Office Action Summary

10/706,965

PUGSLEY ET AL.

DETAILED ACTION

FIG. 2B

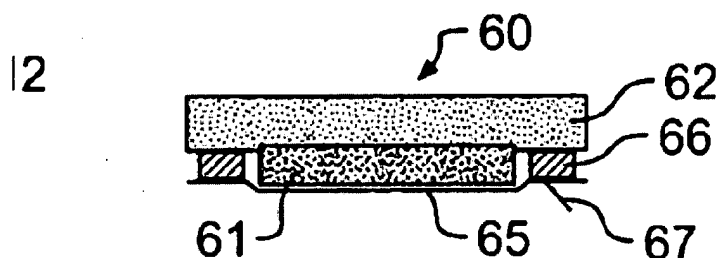
a prior art reference disclosing the structural limitations of the claim, see *In re Pearson*, 494 F.2d 1399, 181 USPQ 641 (CCPA 1974). Examiner further asserts that Applicant's own drawings do not disclose the argued recitation as shown in the reproduced figure below. As shown below, the protective liner does not have any direct contact with the implant.

Additionally, the cellular substrate of Eckert et al. can be a solid layer or be a suspension that is injected into the bandage membrane, to which a the protective liner can be applied.
